2 AM State of New Mexico		Form C-103
Energy, Minerals and Natural Re	sources	Revised July 18, 2013
		WELL API NO.
		30-045-25878 5. Indicate Type of Lease

State Gas Com CA #1 San Juan County, NM

Proposed TA

Operator:	OGRID:
CROSS TIMBERS ENERGY, LLC	298299
400 West 7th Street	Action Number:
Fort Worth, TX 76102	450796
	Action Type:
	[C-103] NOI Temporary Abandonment (C-103I)

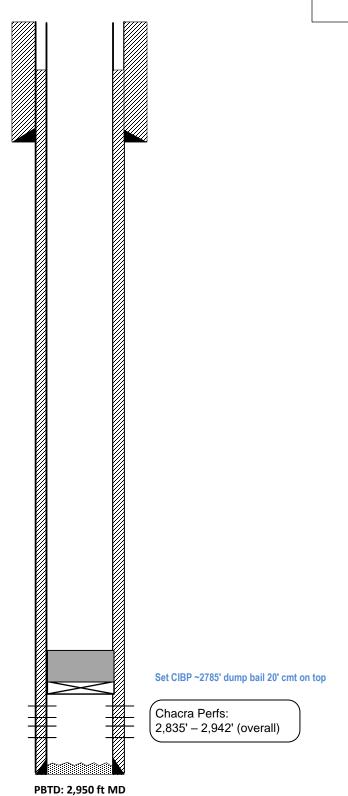
Created By		Condition Date
mkuehling	Chacra top is at 2781 - if plugging off Chacra will need to bring cement 35 feet above Chacra top when using a dump bailer - Notify NMOCD 24 hours prior to moving on - Bradenhead test required prior to MIT day of MIT.	5/1/2025
